# Appendix 9

# Reedy Creek Feasibility Study

**Reedy Creek Stream Restoration and  
Watershed Enhancement Project  
November 22, 2011 – 10:00 a.m.  
On-Site @ Reedy Creek Nature Preserve and Park**

From: Jones, Amanda D SAW [<mailto:Amanda.D.Jones@usace.army.mil>]  
Sent: Tuesday, June 26, 2012 12:21 PM  
To: Karl, Jarrod  
Cc: Johnson, Alan ([alan.johnson@ncdenr.gov](mailto:alan.johnson@ncdenr.gov))  
Subject: Reedy Creek Feasibility Study Area

**Figure 2**  
Concept Restoration Approaches

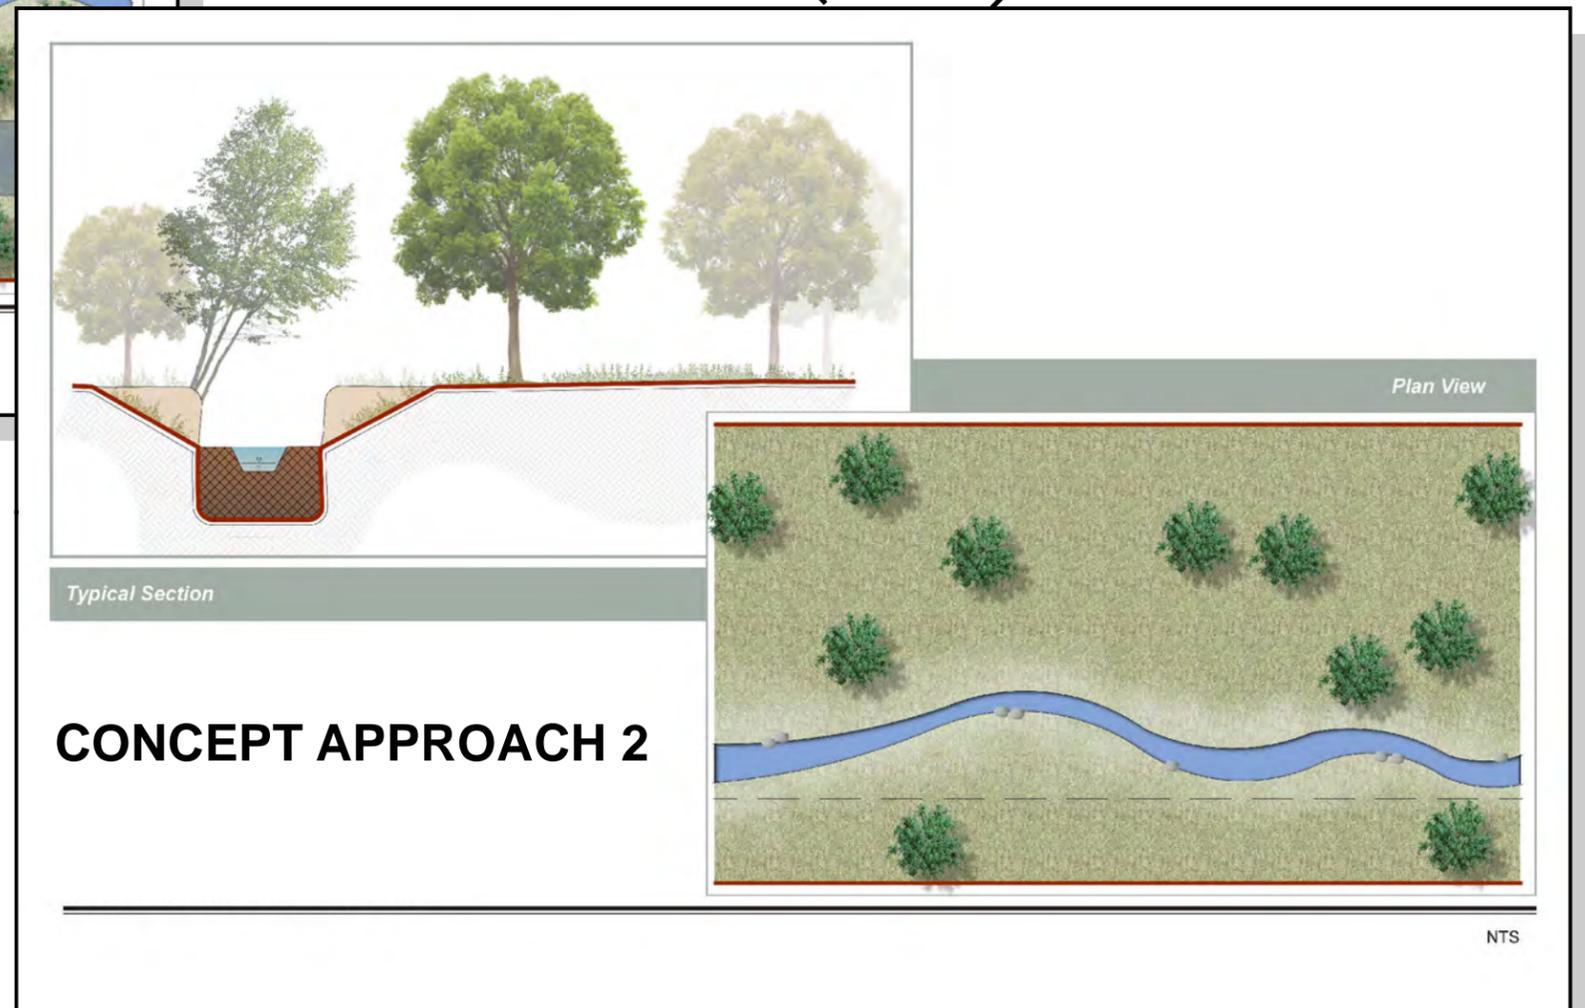
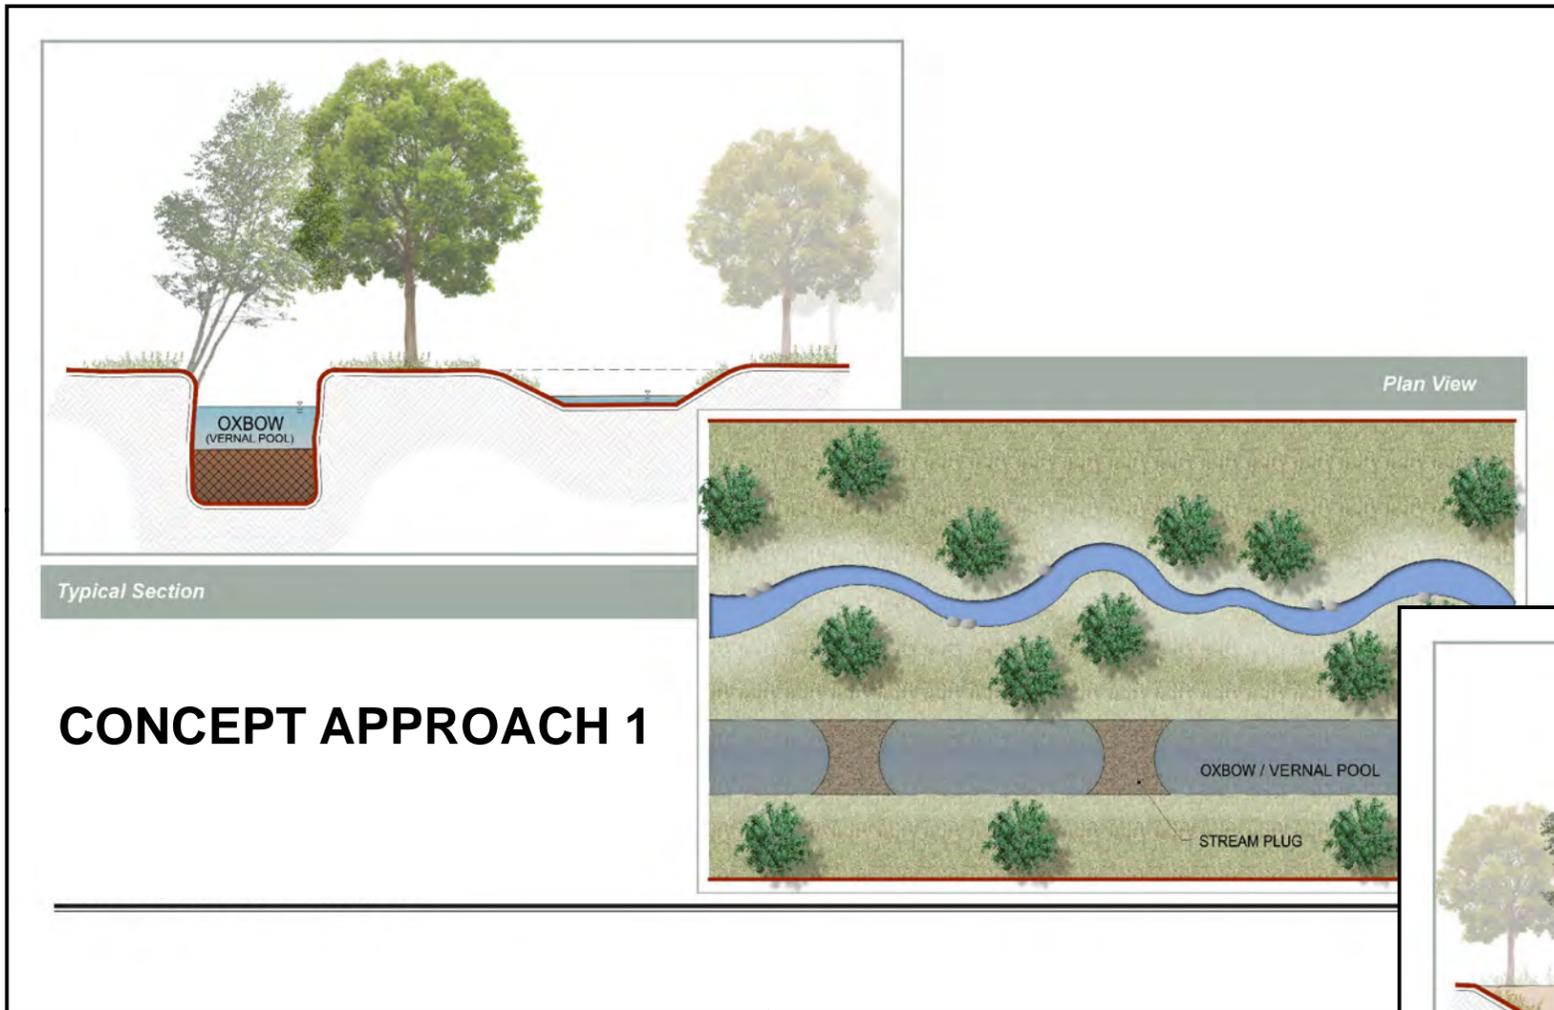
- The group agreed that the upper portions of Reach 5 was a stable reach and provided a good reference.
  - o KHA also noted that the upper sections of Reach 2 above the ponds are also stable and could also be used as reference.

- Agencies agreed that this reach is visually the most impaired they saw in the park.
- NC DWQ expressed concern that if priority one restoration (i.e. raising the stream bed 6-8 feet) is used, would ground water respond .
  - o CMSWS pointed out that similar projects in the County (i.e. Edwards Branch Phase III) where priority one was used, the ground water has responded favorably and stream base flow returned almost immediately to the newly constructed channel.
  - o KHA pointed out that it will be important to plug the old channel to prevent it from being a drain which could pull down ground water.

- All parties agreed that this stream segment is entrenched (i.e. has abandoned its historic floodplain) with bank heights over six feet.
- NC DWQ noted some areas of stable banks among the vertical eroding banks.
  - KHA noted that although there are some short segments where the bank has sloughed in and have become temporarily stable the overall reach is unstable and still actively eroding.
  - City noted that the stream lacked habitat/bed form diversity (i.e. no riffle and pools).
- All agreed the outlet of Dragonfly Pond provided a good starting point and the elevated invert elevation of the outlet pipes allowed for an opportunity to raise the stream bed up.
- The group also noted some relic gabion baskets and/or Reno mattress downstream of the pond outlet. The group agreed that this area could be improved.

- The group agreed this reach is incised/entrenched with vertical eroding banks.
- USACE and NC DWQ asked about storm water inputs from the neighborhood into reach 3 and 4.
  - The City stated that a portion of the neighborhood drains to a wet pond on Reach 4.
  - KHA stated that a priority one restoration would allow the existing stream segments around stormwater inputs to be converted into pocket BMPs to provide treatment prior to the stormwater reaching the relocated priority one restored stream.
